**SITE INSTRUCTION**

**SI – 20**

**Project:** **Aquavista – (Bayside Block 3 R3 & R4, Merchants Wharf)**  
 1 Edgewater Drive, Toronto  
 (Formerly referenced as 263 Queens Quay East)

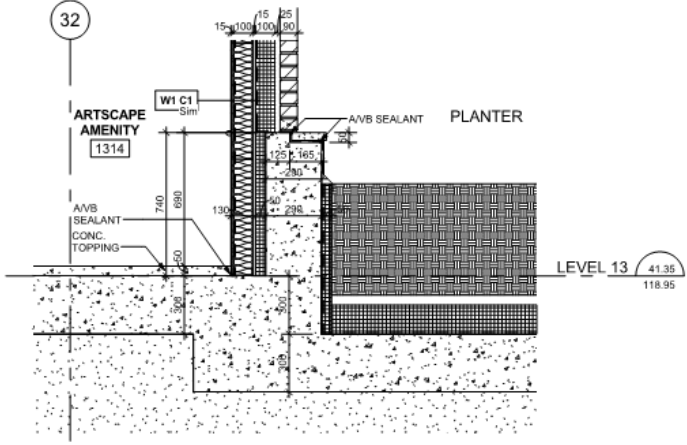
<p><b>.13</b></p>	<p>Level 13; Revise detail 5/ A7-13A, the concrete curb detail has been coordinated with the slab edge drawings between the outdoor planter and the Artscape Amenity 1314 (at the window wall).</p> <p>The detail below has been provided for clarification of the section through the brick wall.</p> 	<p>A7-13A A9-65, A9-66</p>
<p><b>*N.B.*</b></p>	<p>All referenced drawings are available for immediate download from the KIRKOR/Newforma InfoExchange for a period of 30 days.</p> <p>All referenced drawings have been uploaded to the Astley Gilbert DFS for immediate printing / access.</p>
